# UNITED STATES PATENT AND TRADEMARK OFFICE

10/596,694

<b>Office Action Summary</b>	<b>Application No.</b> 10/596,694	<b>Applicant(s)</b> D'ARRIGO, ANGELO	
	<b>Examiner</b> BRYAN P. GORDON	<b>Art Unit</b> 2837

### **DETAILED ACTION**

**Figure A**

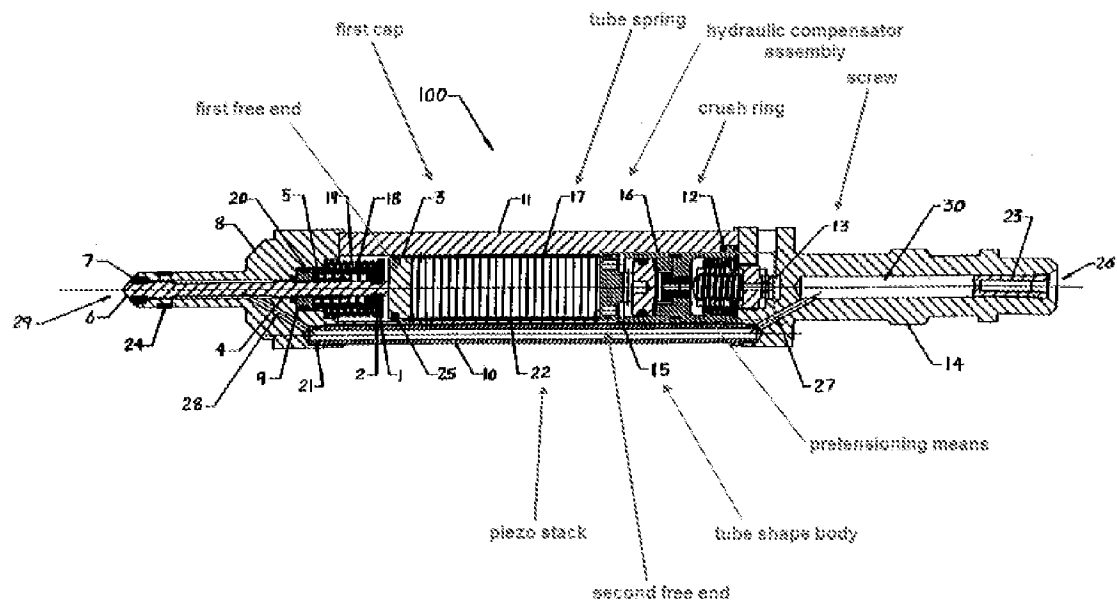
5. Considering claims 1 and 10, Shen (Figure A) teaches a piezoelectric actuator unit comprising: a tube spring (17); a piezoelectric actuator (22), that is inserted into the tube spring, a first cap (3), that is connected to the tube spring at a first free end (See Figure A above) of the tube spring and which is adjoined by the piezoelectric actuator (22), a tube-shaped body (15) that is connected to the tube spring by joining and is arranged in the area of a second free end (see Figure A), and a means for pretensioning that is supported by the tube-shaped boy (col. 5 lines 52-54), and pretensions the piezoelectric actuator (col. 5 lines 49-57).

6. Considering claims 4 and 13, Shen (Figure A) teaches a thread in the tube-shaped body and wherein the pretensioning means is a screw (13) that is screwed into the thread.

15. Applicant's arguments filed 15 May 2009 have been fully considered but they are not persuasive. Regarding the argument that screw 13 merely adjusts the axial location of the hydraulic compensator assembly 16 and does not pretense the tube spring as noted above in Figure A the pretension means includes the screw 13, crush ring 12, hydraulic compensator 16 and the tube spring 17 which does help pretense the piezoelectric actuator. As the screw 13 is adjusted it would add stress or pressure to the tube spring via the compensator assembly and crush ring which pretense the piezoelectric actuator. Therefore, the applicant's argument is moot.

Figure B

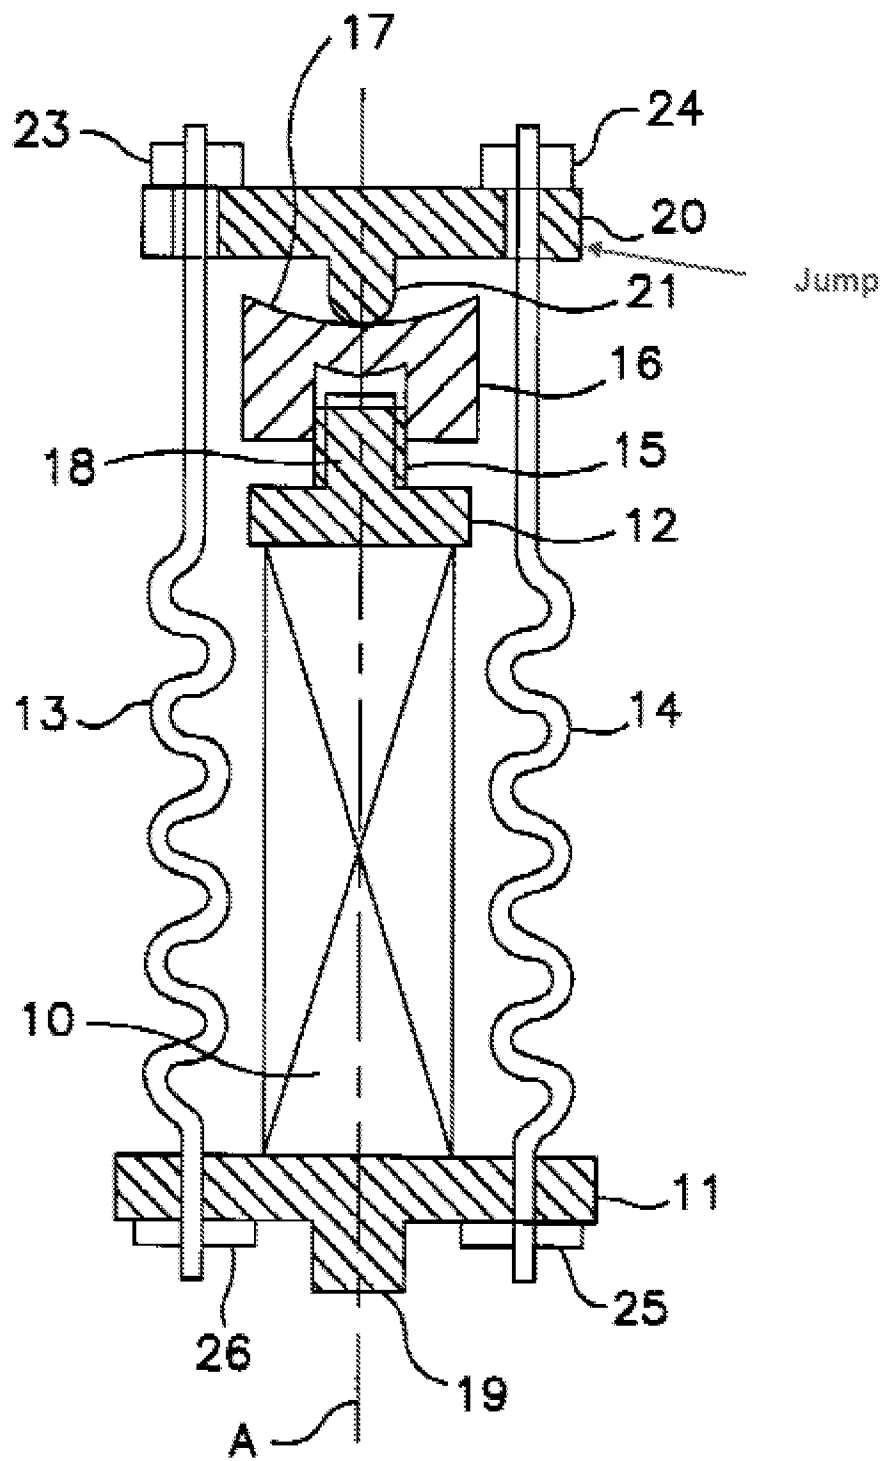
13. Considering claims 6 and 15, Mattes (Figure 1) teaches the tube-shape body has a jump in its diameter on its outer circumference.
